342-49-037

SERVICE BULLETIN

Application of grease required on the two fuel manifolds

Figure 1 : Burner manifold - Remove procedure

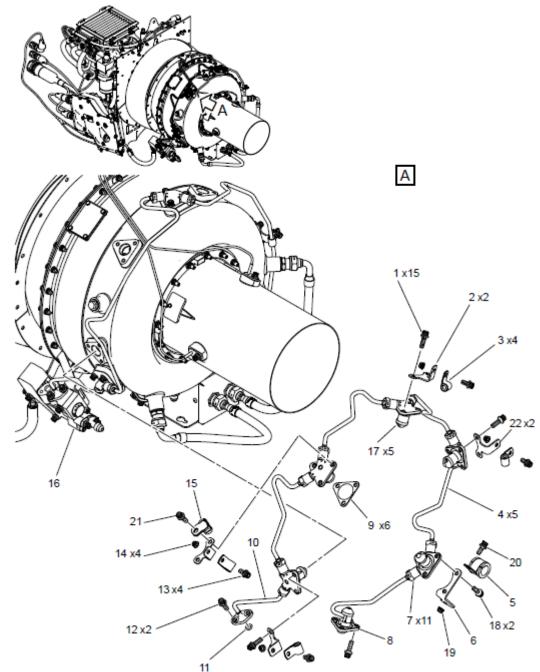
- Do not lubricate the threads of the nuts (7).
- Apply a small amount of grease AIR 3565/A to the location shown in the Figure 2.

Lubricate the rear part of the 11 burner manifold ferrules with grease AIR 3565/A.

- 3. Tighten by hand the 11 nuts (7, Figure 1) of the five fuel lines (4, 10).
- 4. Torque the eight screws (1) to 5 Nm (44.254 lbf.in) with a standard torque wrench or a special torque wrench (M25740).

- 5. Torque the 11 nuts (7) to 11 Nm 12 Nm (97.360 lbf.in 106.210 lbf.in) with a standard torque wrench or a special torque wrench (M26470).
- 6. Torque the 7 screws (1), the screw (21) and the 2 screws (18) to 5 Nm (44.254 lbf.in) with a standard torque wrench or a special torque wrench (M25740).

- 7. Make sure that the tightening torque of the 15 screws (1), the screw (21) and the 2 screws (18) is 5 Nm (44.254 lbf.in) with a standard torque wrench or a special torque wrench (M25740).
- 8. Lock the 11 nuts (7) with Lockwire.

Figure 3: Ignition manifold - Remove procedure

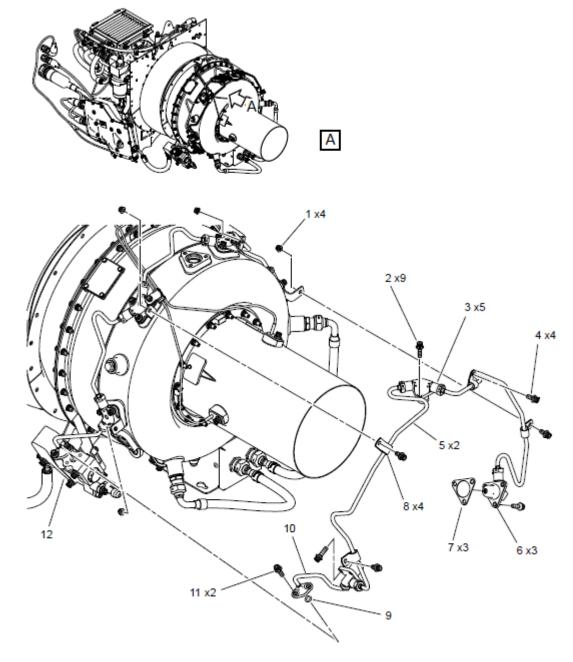
- Do not lubricate the threads of the nuts (3).
- Apply a small amount of grease AIR 3565/A to the location shown in the Figure 2.

Lubricate the rear part of the five ignition manifold ferrules with grease AIR 3565/A.

- 3. Tighten by hand the five nuts (3) of the five fuel lines (5, 10).
- 4. Torque the nine screws (2) to 5 Nm (44.254 lbf.in) with a standard torque wrench or a special torque wrench (M25740).
- 5. Torque the five nuts (3) to 11 Nm 12 Nm (97.360 lbf.in 106.210 lbf.in) with a standard torque wrench or a special torque wrench (M26470).
- 6. Lock the five nuts (3) with Lockwire.
